96N120 PH 6 SUBDIVISION PLAT

DATE DESCRIPTION
GREAT BASIN	B E N G I N E E R I N G C	5746 SOUTH 1475 EAST OGDEN, UTAH 84403 Main (801)394-4515 S.L.C (801)521-0222 FAX (801)392-7544 W W W . G R E A T B A S I N E N G I N E E R I N G . C O M	REV
Plan / Profile (Utility)	The Chalets at Ski Lake No. 7	A part of the Southwest 1/4 of Section 13, a part of the Northeast 1/4 of Section 23, and a part of the Northwest 1/4 of Section 24,	T6N, R1E, SLB&M, U.S. Survey
Not 166484 MARK EUGENE BABBITT Jan, 2012 SHEET NO.

96N120 Waterline

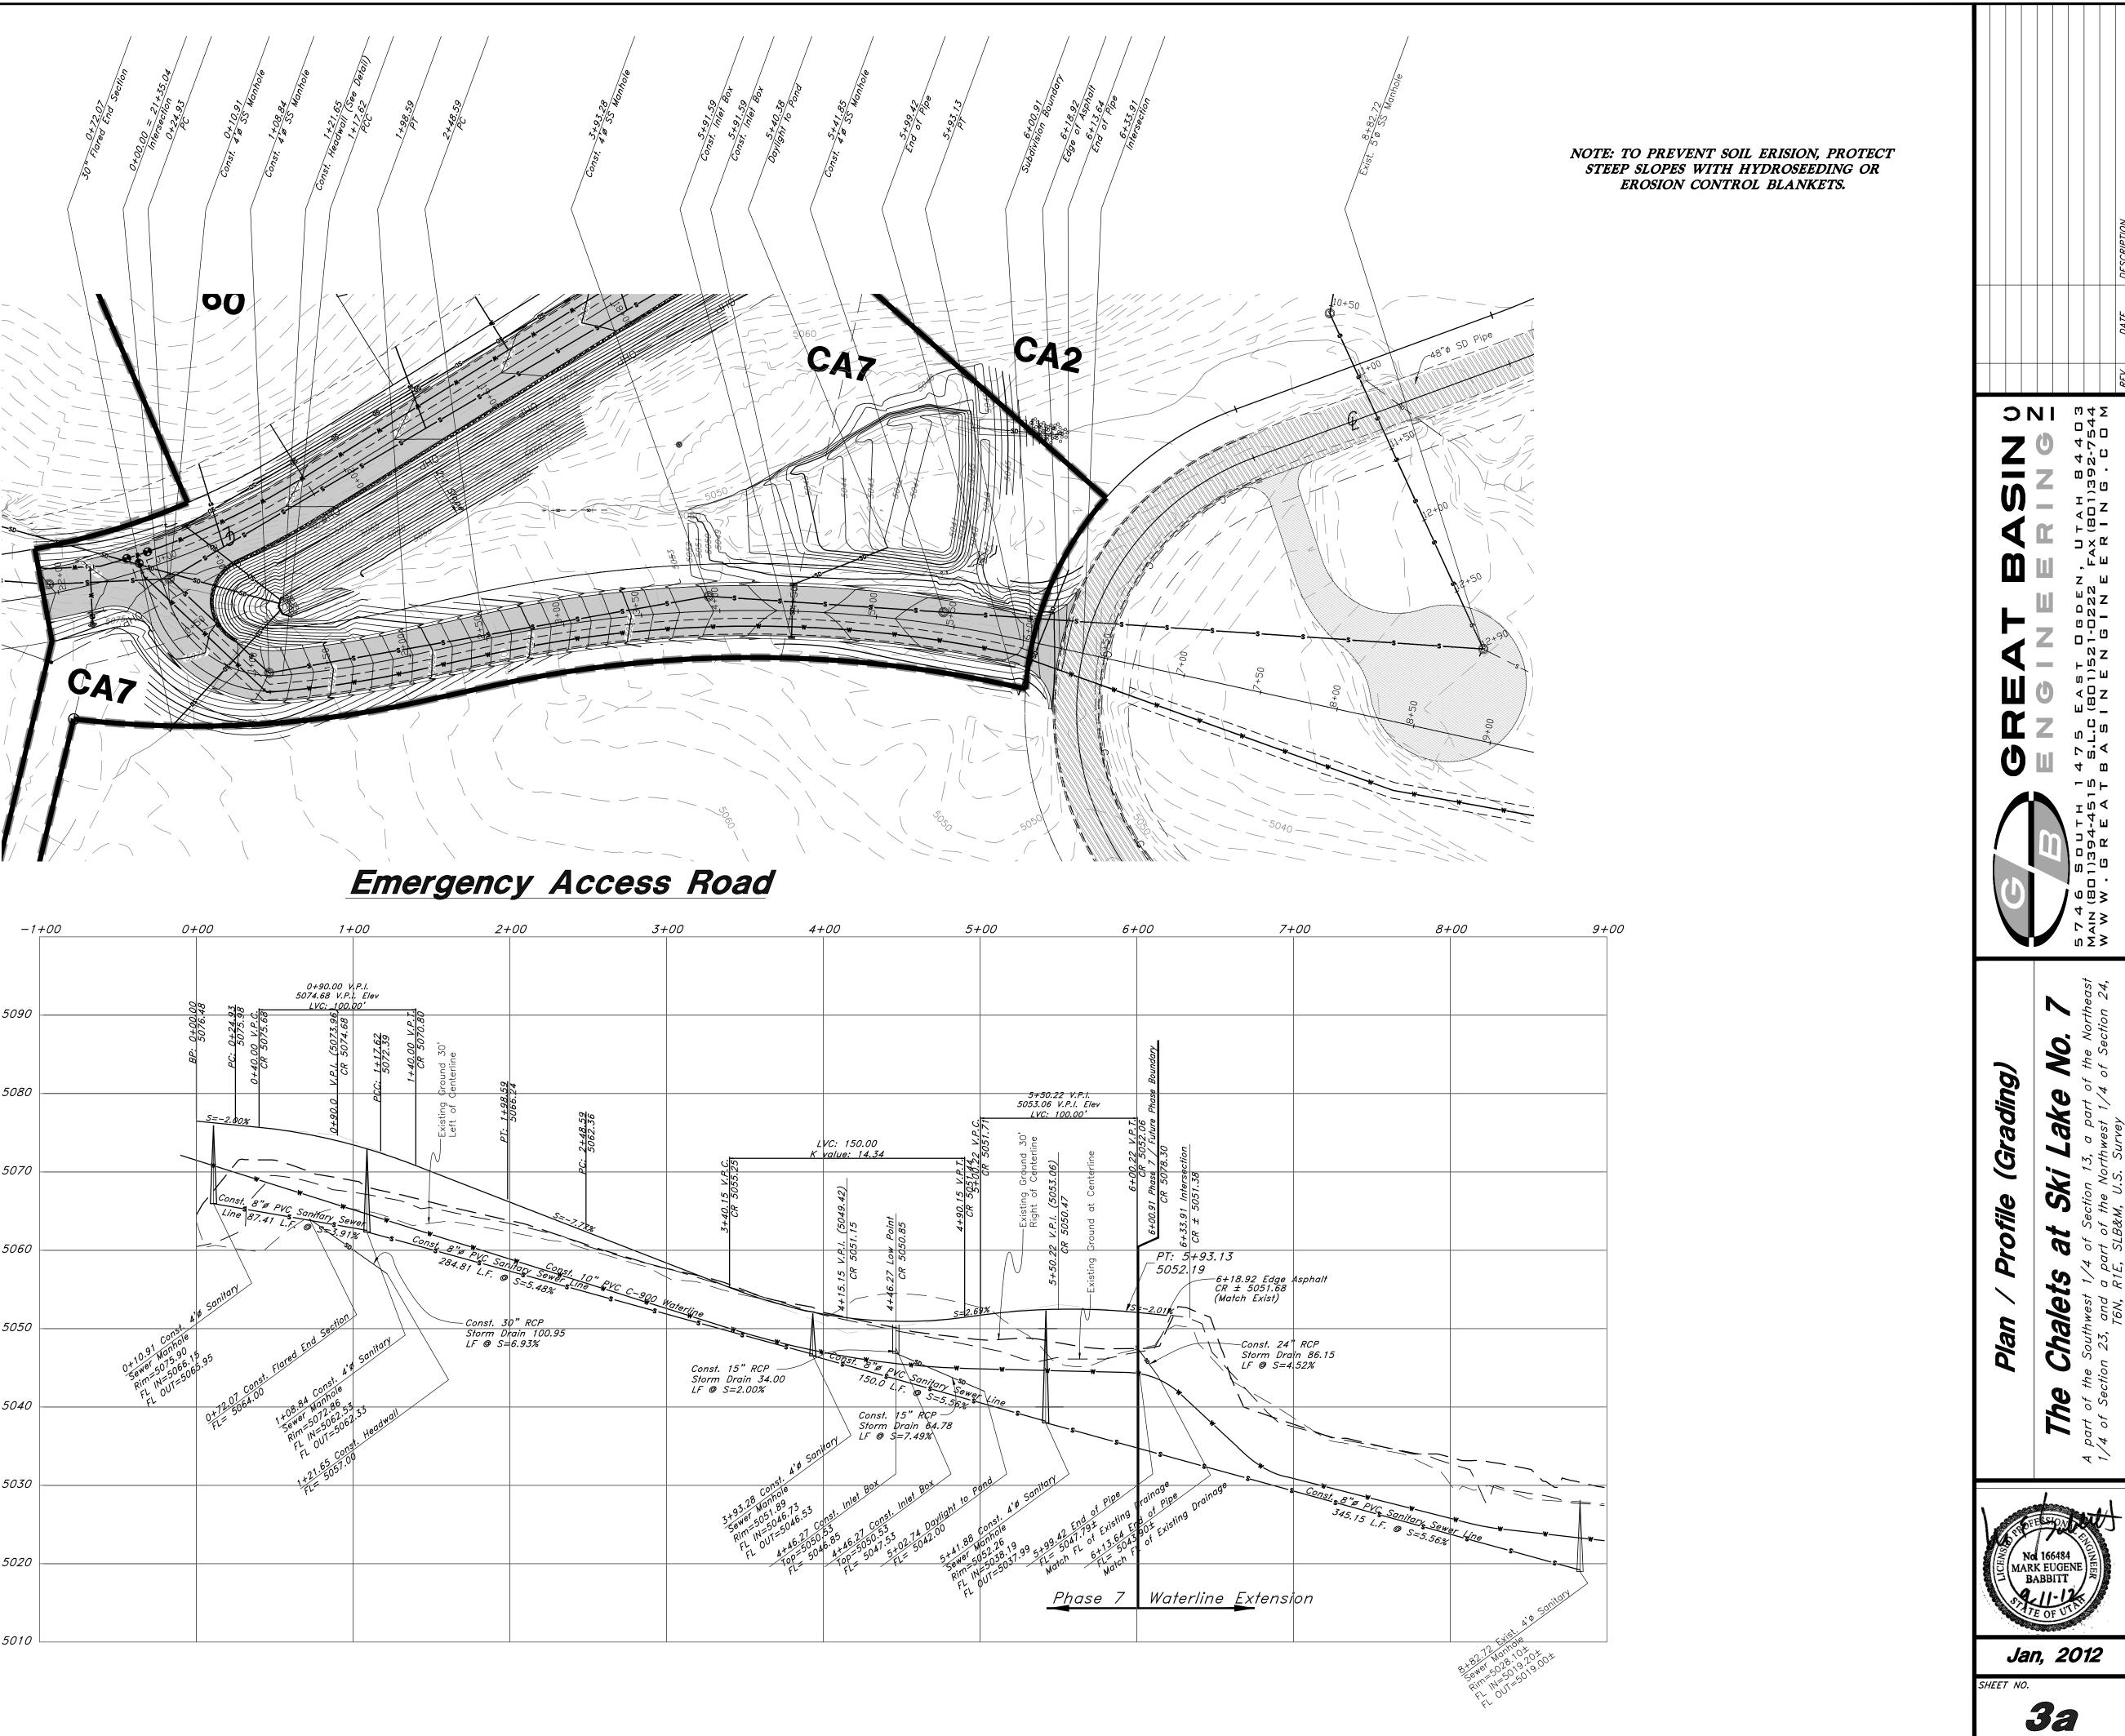
How was the sizing – of these pipes determined? What are the flows they are taking? See attached Storm

Water Study for calcs on these two pipes.

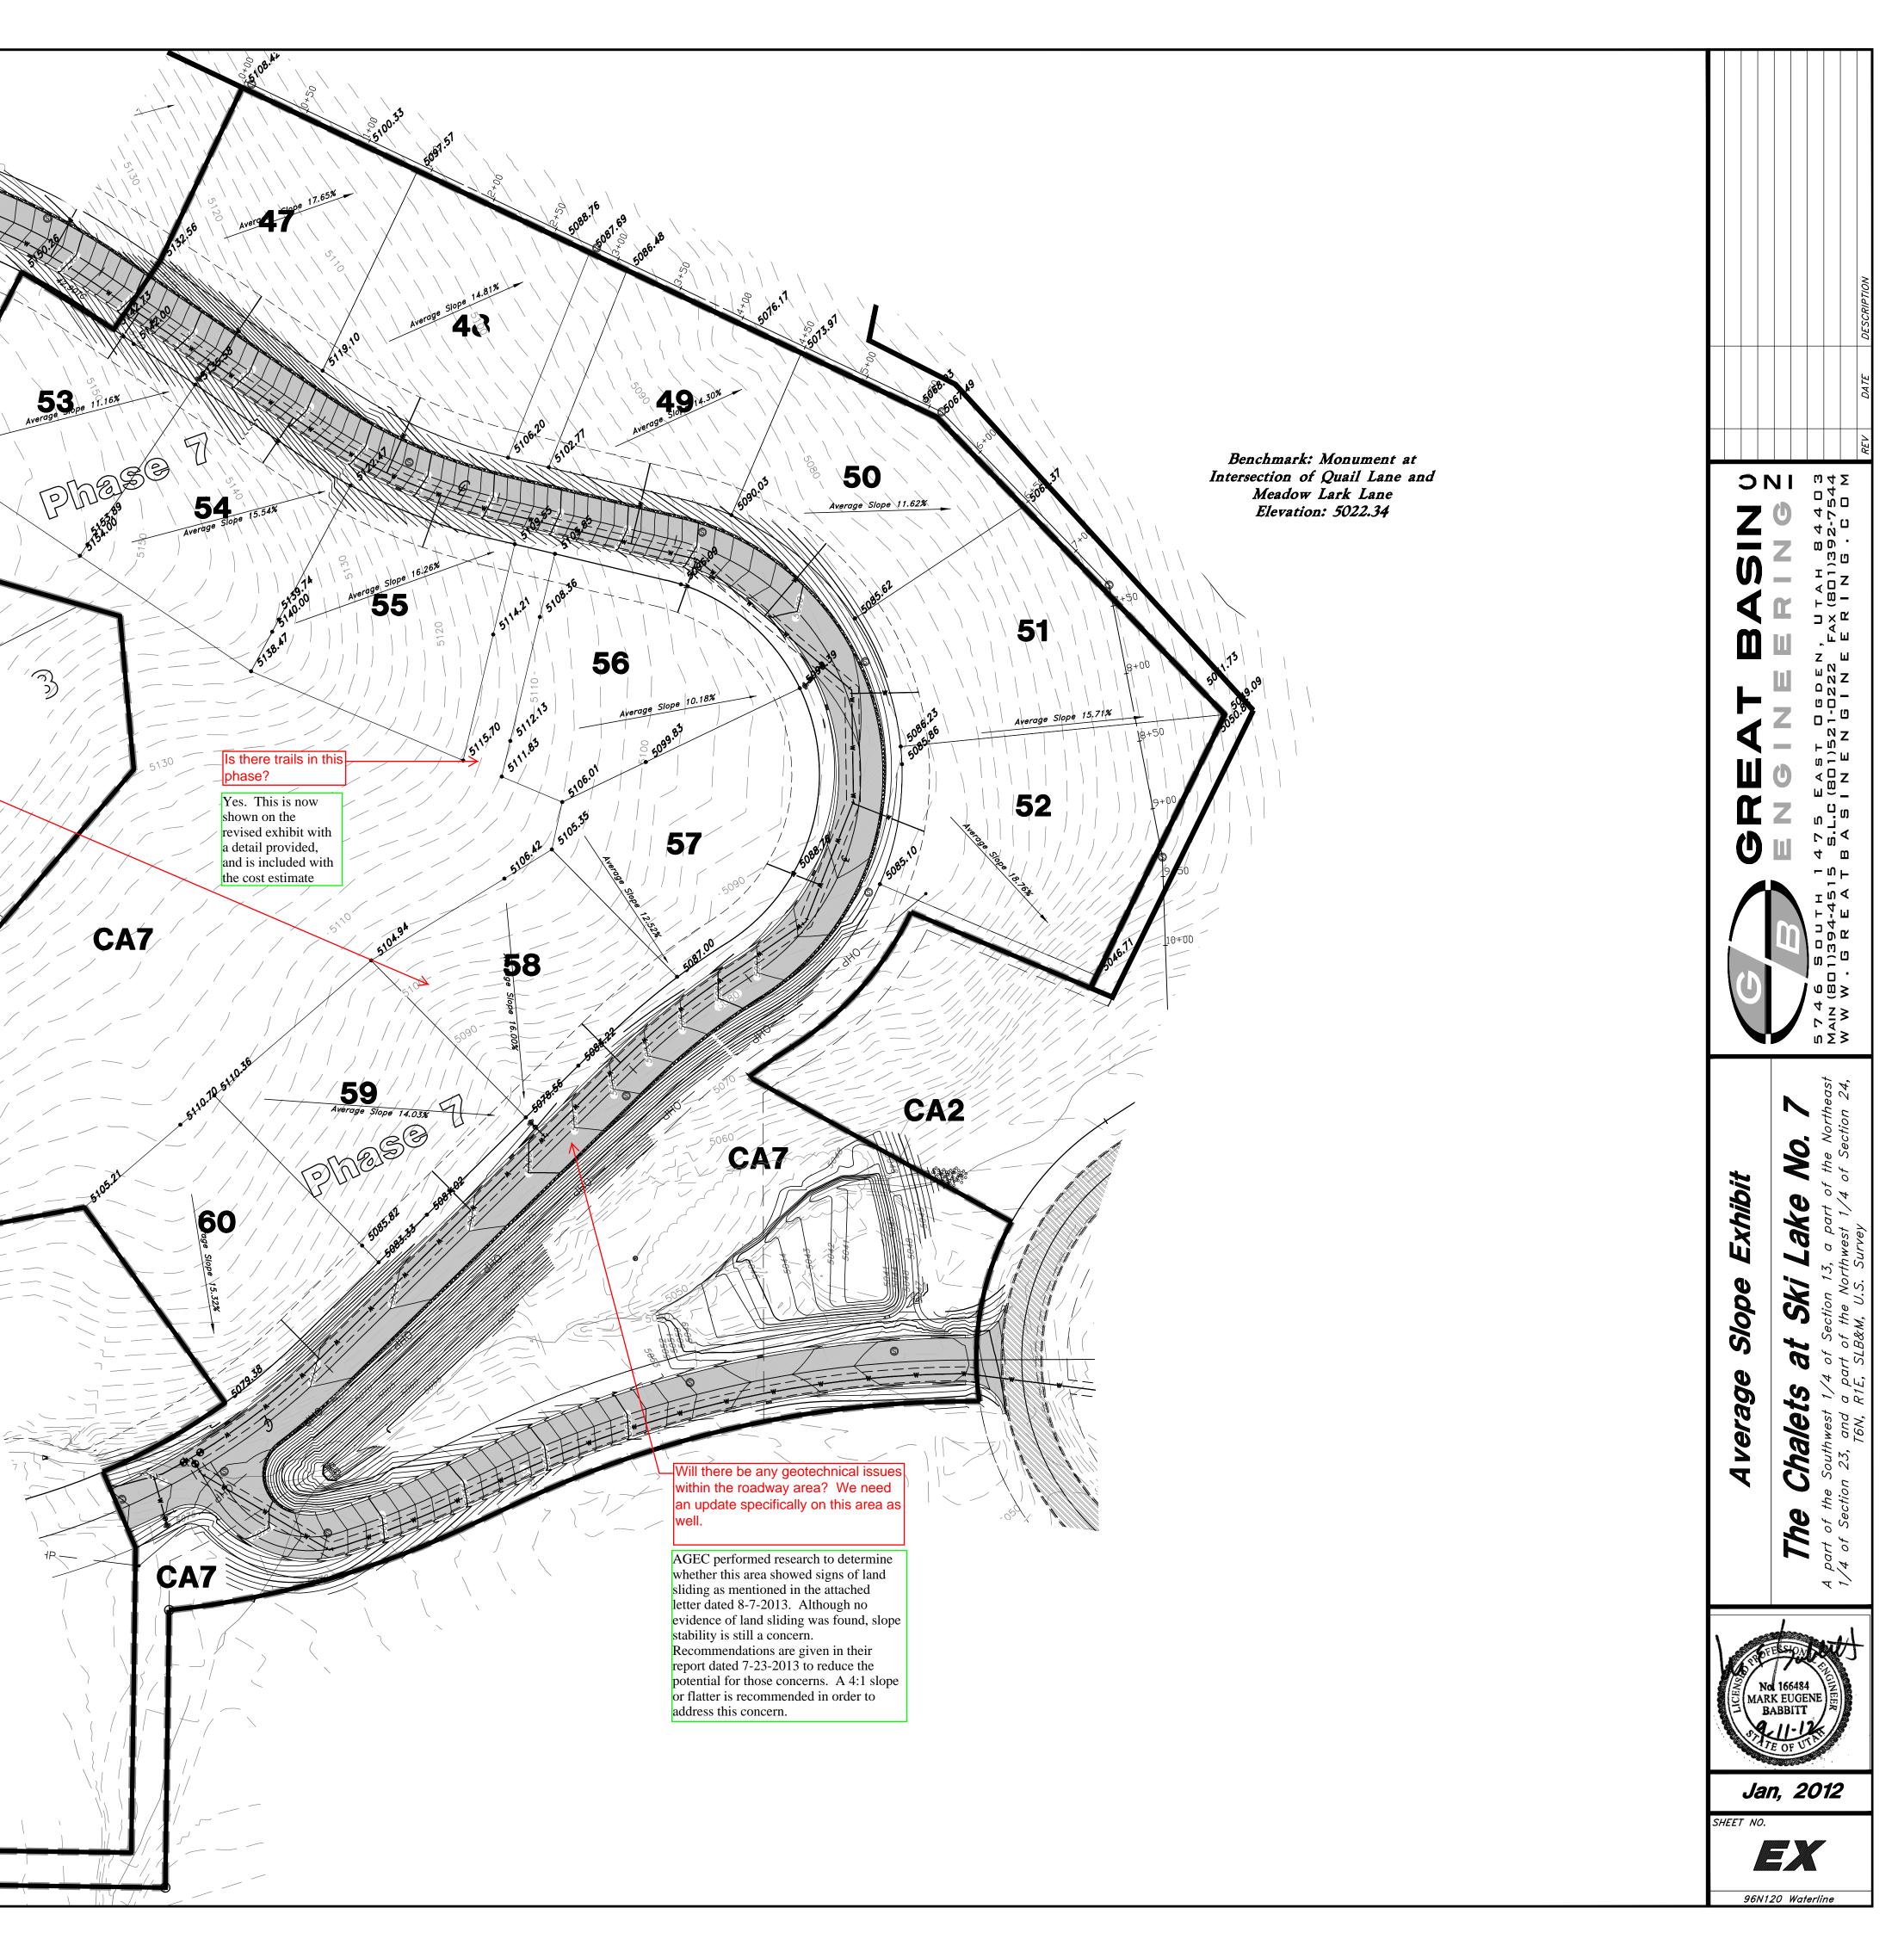
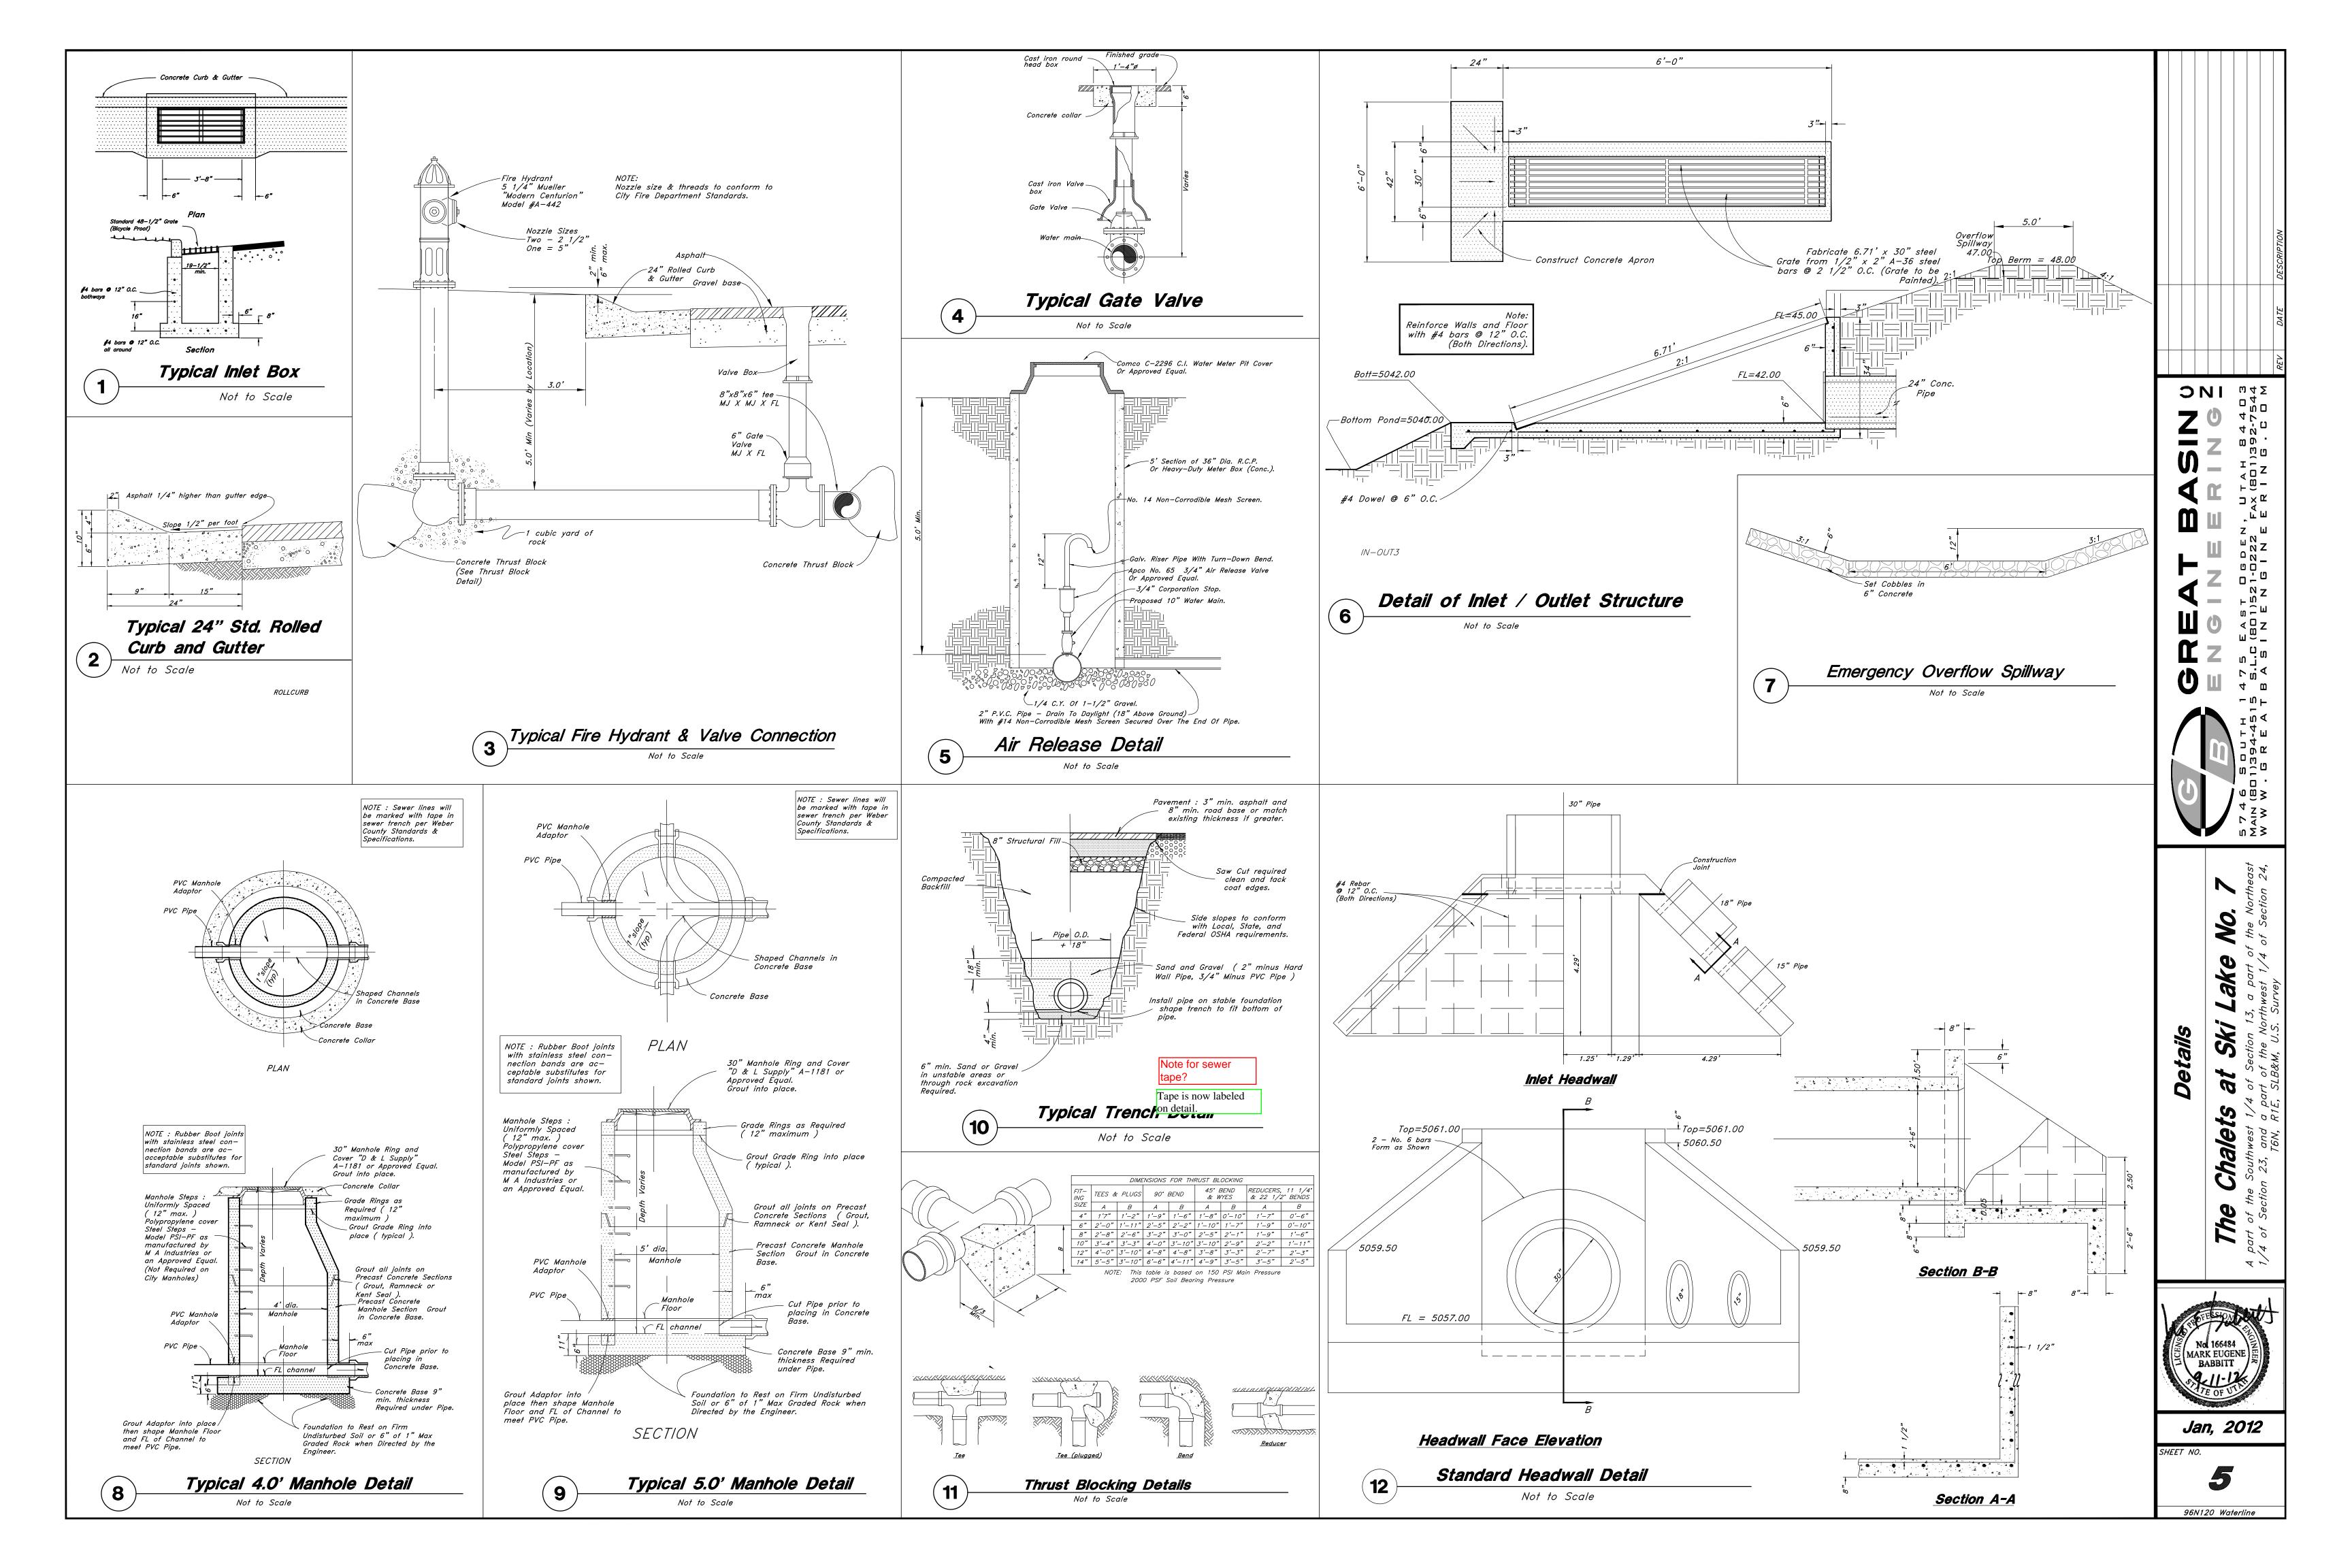
calling out possible issues here with this drainage. I think we need a Geotech to look at this area. R-Lots?? Does there need to be an easement?

An updated Geotechnical Report for Phases 7 and 8 that addresses this area is attached. Also included is a letter specifically about these two lots. This letter recommends natural slopes to be a maximum of 4:1. These two lots are an average of about 6:1 using a water drop analysis. Therefore, no additional measures are necessary
